City of Portland Design Commission

Design Advice Request

SUMMARY MEMO

Date: 8/25/2020
To: Ralph Tahrán | Tahrán Architecture & Planning
From: Tanya Paglia, Design Review
503-823-4989 | tanya.paglia@portlandoregon.gov
Re: EA 20-158166 DAR – 2055-2057 & 2061 SW Park Ave | SW Park Apartments
Design Advice Request Commission Summary Memo – 8/6/2020

MASSING STUDY

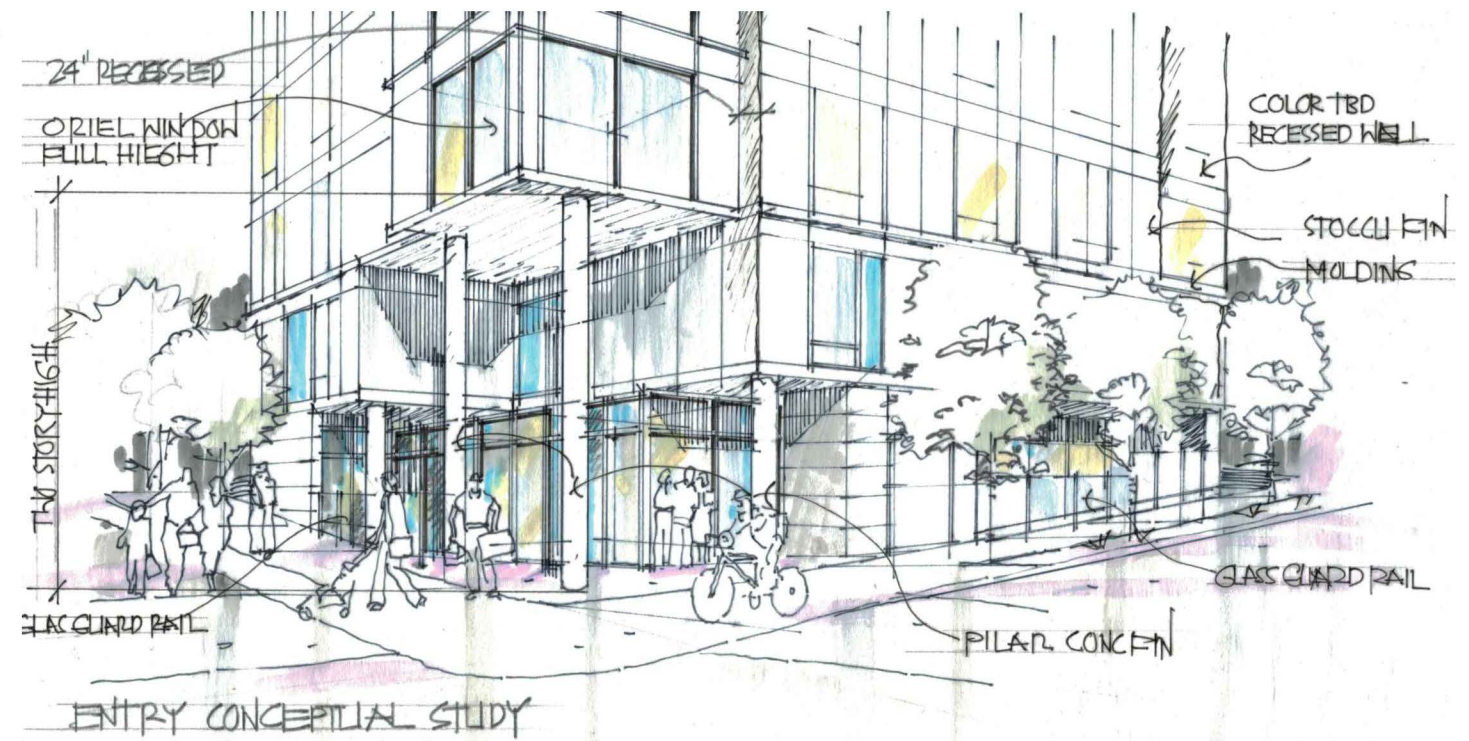
- The corner treatment orients the building to the city and is very successful.
- Main entrance and entry colonnade are fantastic and working well.
- The arcade overhang provides sufficient weather protection.

- The sunken elements of the building are not yet working and architectural craft is needed to resolve the building base.
- Consider utilizing the site's grade change to improve the ground floor conditions overall.
- The sunken courtyard along Clifton poses safety problems creating a dark secluded condition with no eyes on the street.
- Explore making the courtyard space interior amenity space rather than exterior to improve safety.

- While larger than most of the surrounding development, the building's scale is allowed by zoning development standards so not a focus of Design Review but designing the building to blend with neighborhood is key to meeting Design Review guidelines.
- This neighborhood is across a large freeway from PSU. The proposed building is in a different neighborhood and needs to respond better to its immediate setting.
- Foremost, the building does not look residential and has the appearance of an office building which does not mesh with the residential context of the neighborhood. More human-scale detail is needed.
- The lack of horizontal changes in the massing make the building feel larger and the building skin needs more work responding to context – more detailing and texture and less monolithic glazing.

PERSPECTIVE

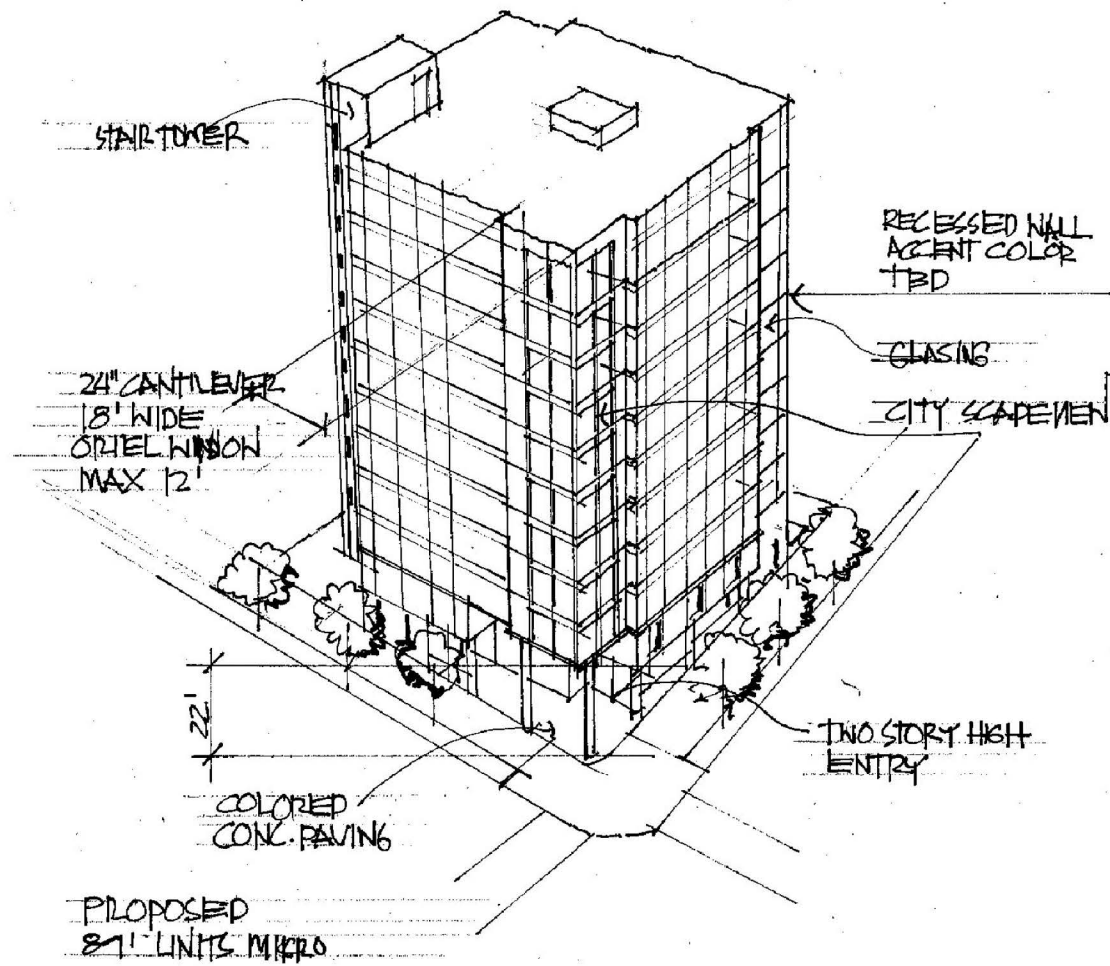
- Residential balconies carried up the building would enrich the façade, adding detail, human scale and visual interest which it currently lacks and would contribute to it not looking like an office building. Recessed balconies would provide welcome façade shifts.
- The oriel window contributes to the commercial quality of the building – takes away from the contextual response. Balconies deployed where the oriel is could improve response to context.
- Balconies would also provide great for views from the building for residents.

- Give thought to developing the building skin to add detail and create less glare (so that not every surface is glazing).
- However, more glazing on the west and south facades would be welcome.
- While the oriel is nice, units with floor to ceiling glass is not ideally livable.

1 LEVEL 1
SCALE 3/32" = 1'-0"

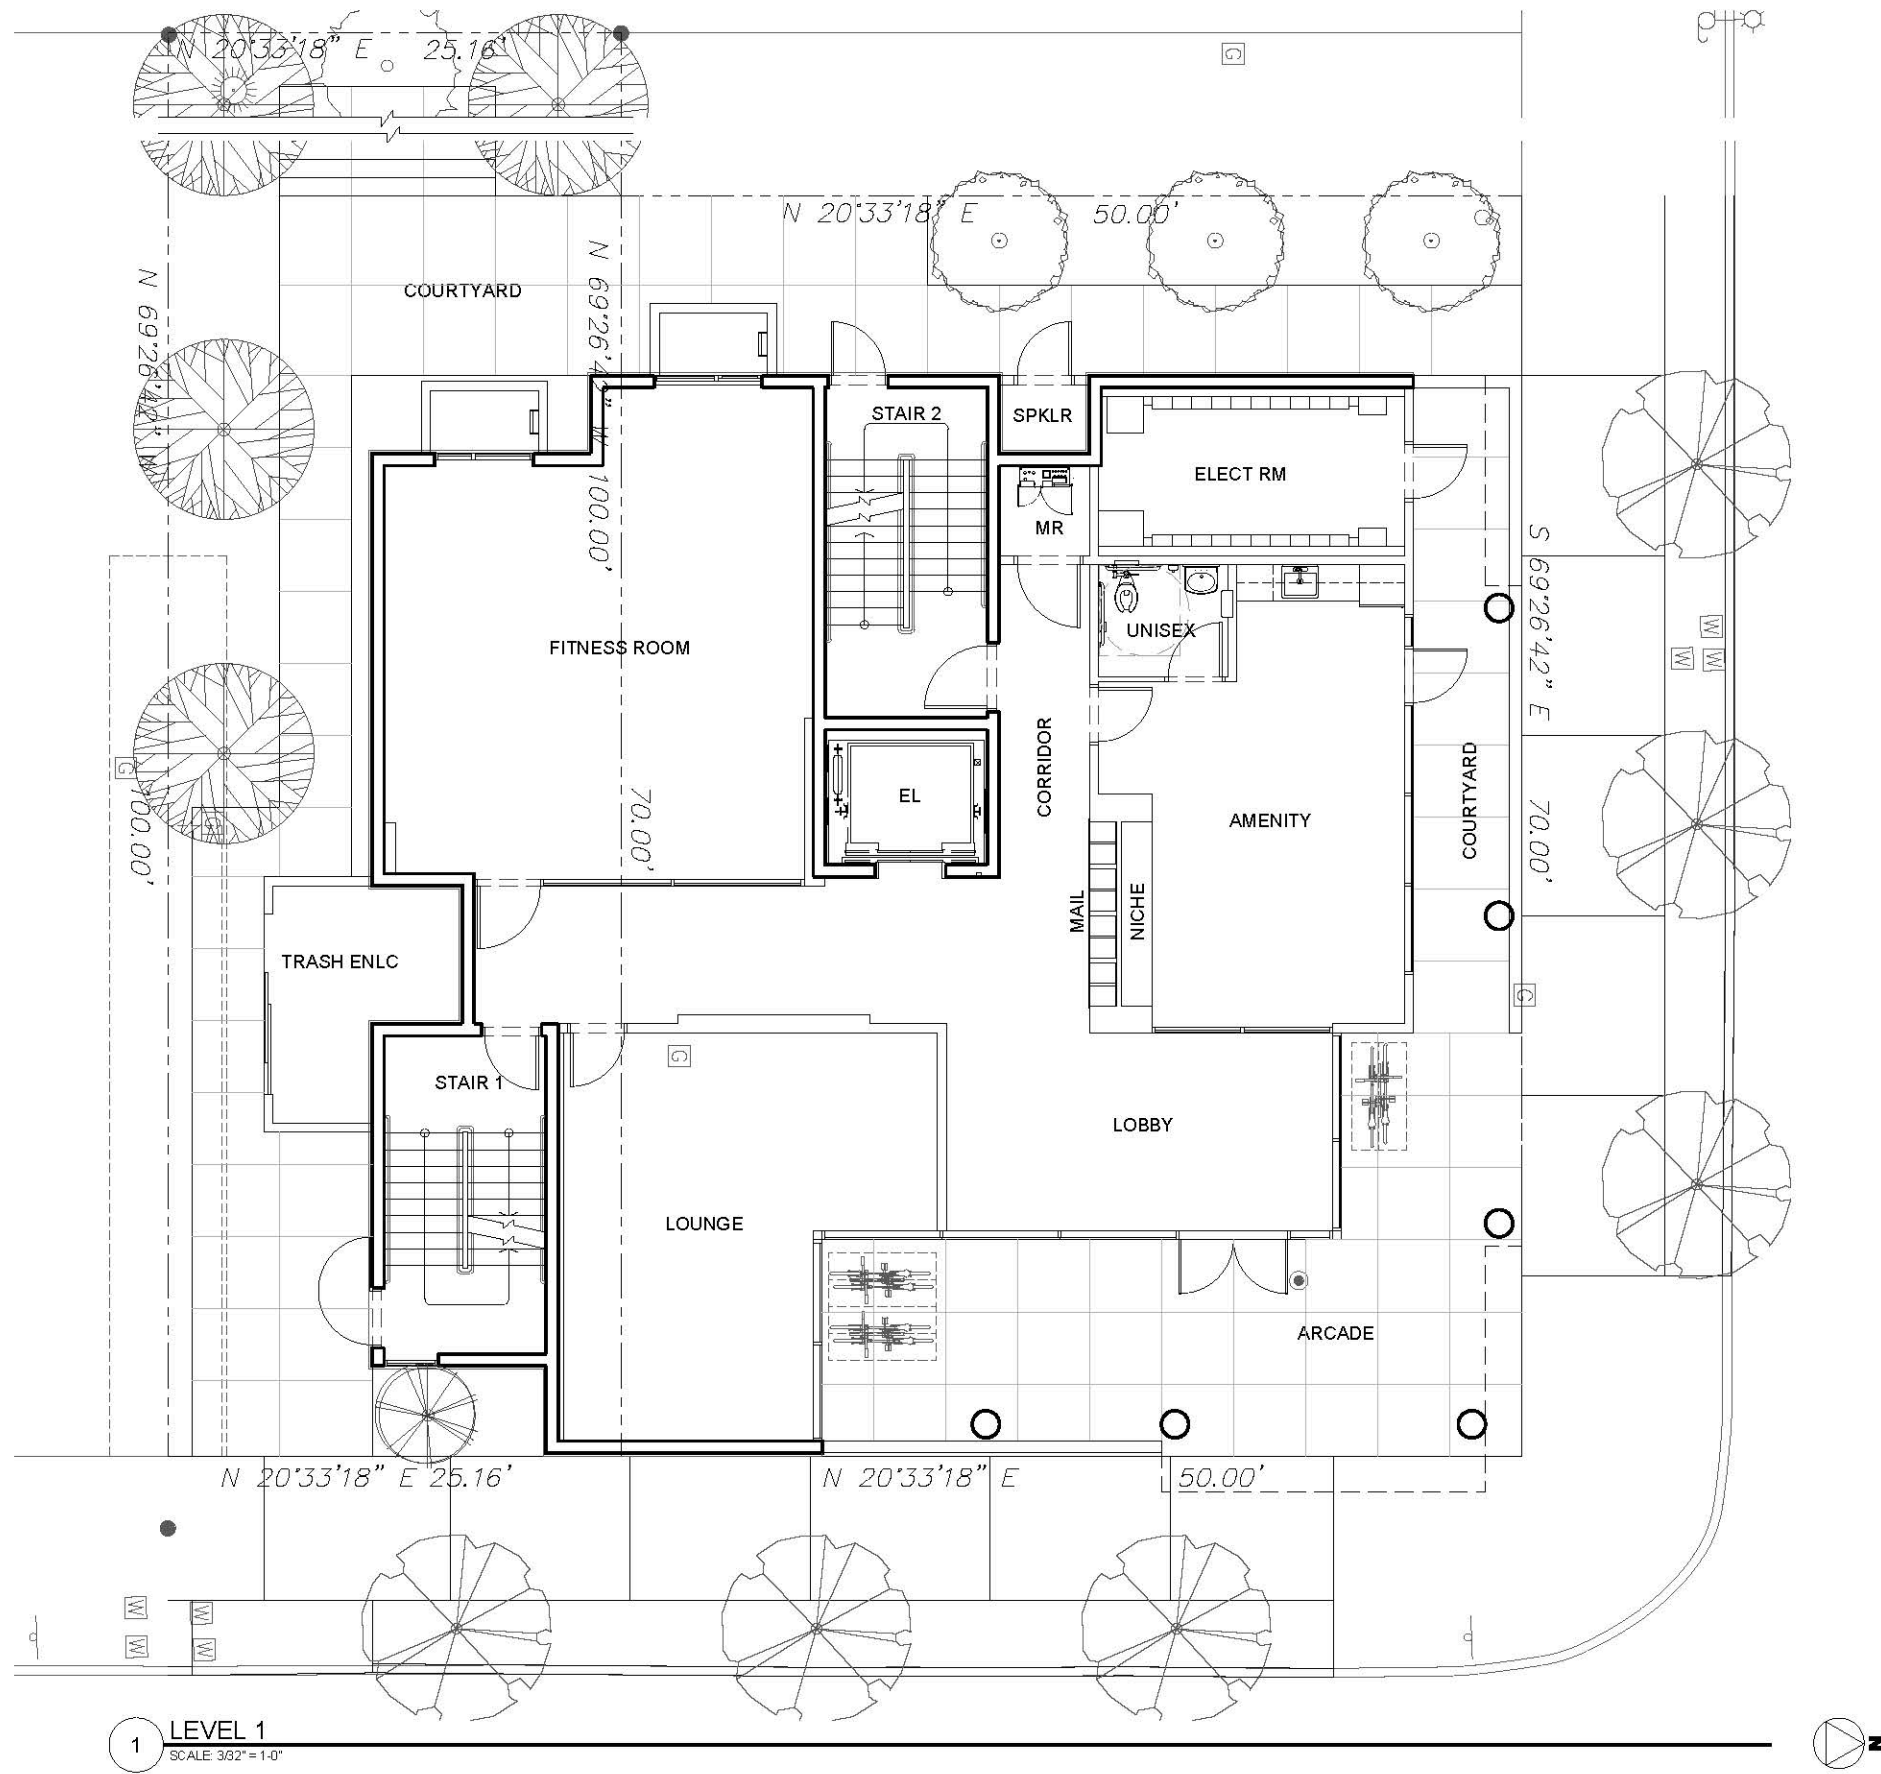
- The lounge's solid blank street facing ground floor wall is an easy fix. Transparency should be added to the exterior wall to activate the façade and add eyes on the street to the Park Ave frontage.

- Explore alternative strategies to take all of the back of house functions – loading, electrical, etc. – and put them all on one street. Having back of house frontage along both streets makes both worse. Need to consolidate and make one street great.
- Could the slope be used to create a split level to bring utilities in through the alley, and/or could the electrical room be up higher and open to rear of building.
- Could bike parking be pulled up so that people can wheel the bikes in at grade and enhance bike ridership – digging less basement and pushing some of the basement stuff up.

- Put more attention to the loading zone as it won't be in perpetual use as vehicle area. Find ways for it to be a pleasant entrance for pedestrians and contribute to a vibrant streetscape
